# **CREEKWALK NORTH**

**Appeal of Development Plan and Plat  
File Numbers: AR DP 21-00551 and AR FP 21-00552**

# No Improvements Planned for Cheyenne Creek in Phase 1

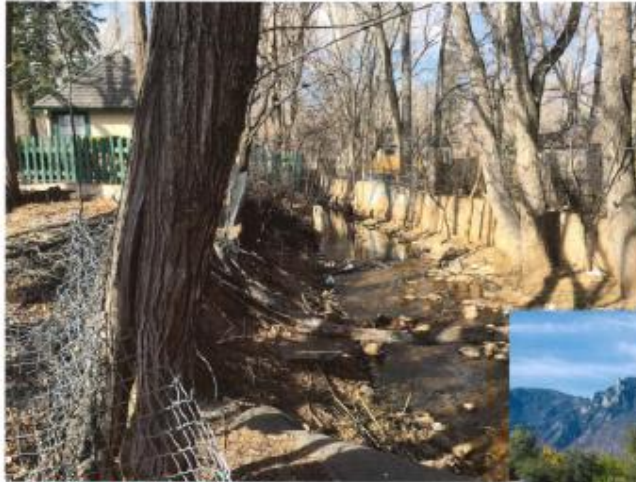
The Plan does not adequately address Steps 3 of the Four Step Process, which requires the stabilization of stream channels.

Even though the Phase 1 Underground BMP outflows directly to Cheyenne Creek, the Plan pushes all Creek improvement and stabilization to Phase 2, with no promise that the next phase will even occur.
